# UNITED STATES PATENT AND TRADEMARK OFFICE

10/525,896

<b>Office Action Summary</b>	<b>Application No.</b> 10/525,896	<b>Applicant(s)</b> PLUMMER, MARCUS	
	<b>Examiner</b> BRANON C. PAINTER	<b>Art Unit</b> 3633

## **DETAILED ACTION**

Reproduced from Halls

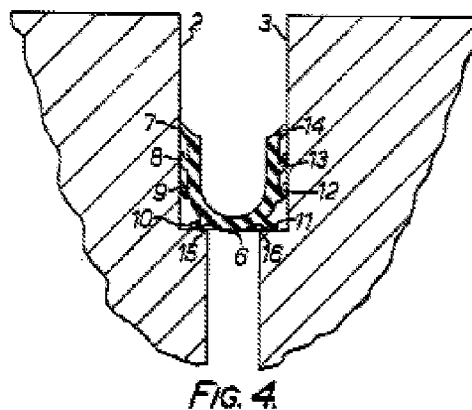
4. Claims 1, 6, and 10 are rejected under 35 U.S.C. 102(b) as being anticipated by Halls (GB 1,380,395).
5. Regarding claim 6, Halls discloses two adjacent panels with sealing strip having all of the applicant's claimed structure, including:
  - a. A sealing strip filling a gap between the panels ("sealing strip" 1 between "surfaces" 2, 3, Fig. 1, 4).

- b. The sealing strip comprising an elongate piece of resiliently flexible plastics material ("sealing strip 1, which is made of a resiliently flexible material such as a polymer or a material including a polymer," lines 87-90). The examiner notes that plastics necessarily include polymers, therefore they are covered by the disclosure of Halls.
- c. The strip being folded about a longitudinally extending line intermediate its opposite side edges and whose sides are biased against the side edges of the respective adjacent panels with the strip inserted completely into the gap between panels ("the strip is resiliently deformable to a generally U-shape with the one face outermost by bending about the central longitudinal axis of the strip and to be positioned in a gap between juxtaposed surfaces," lines 28-33; Fig. 4).

6. Regarding claim 10, Halls discloses a flat strip with a line of weakness along which the strip is folded (“notch” 4, Fig. 1).
  - a. The examiner notes that claim 10 is considered to be a product-by-process claim due to the phrase “pre-formed.” The patentability of the product does not depend on its method of production. Determination of patentability is based on the product itself. See MPEP 2113. If the product in the product-by-process claim is the same as or obvious from a product of the prior art, the claim is unpatentable even though the prior product was made by a different process.” *In re Thorpe*, 227 USPQ 964, 966 (Fed. Cir. 1985).

Reproduced from Bogle

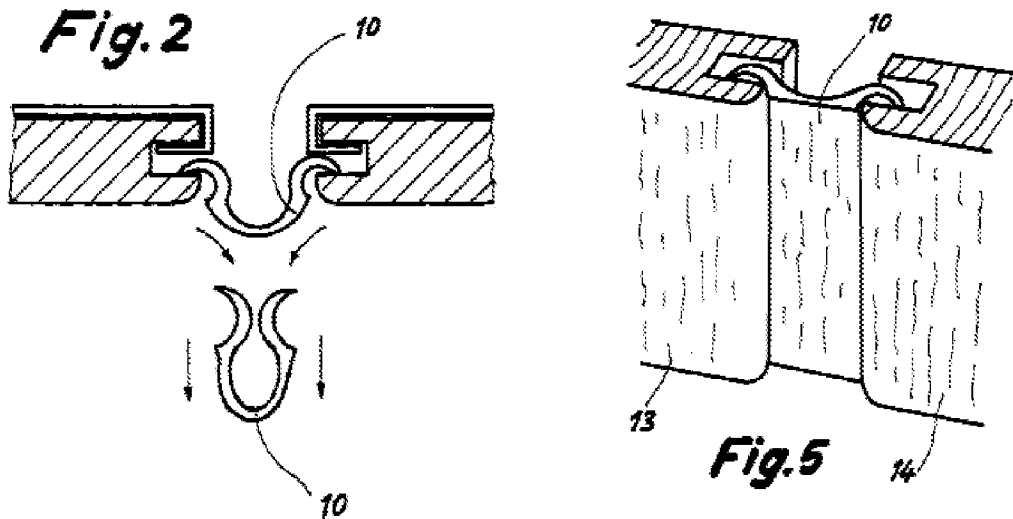
8. Claims 1-2 and 6-7 are rejected under 35 U.S.C. 102(b) as being anticipated by Bogle (EP 0,940,524 A2 – Derwent Abstract).
9. Regarding claim 6, Bogle discloses two adjacent panels with sealing strip having all of the applicant’s claimed structure, including:

- a. A sealing strip filling a gap between the panels (“closure” 10 between “boards” 13, 14, Fig. 2, 5).
  - b. The sealing strip comprising an elongate piece of resiliently flexible plastics material (“The joint closure (10) is of plastics,” Derwent Abstract; Fig. 2 demonstrates the resiliency of the strip).

- c. The strip being folded about a longitudinally extending line intermediate its opposite side edges and whose sides are biased against the side edges of

the respective adjacent panels with the strip inserted completely into the gap between panels (Fig. 2 shows the strip folded along the axis and being inserted into the gap between panels; Fig. 5 shows that the strip lies completely within the thickness of the panels after installation).
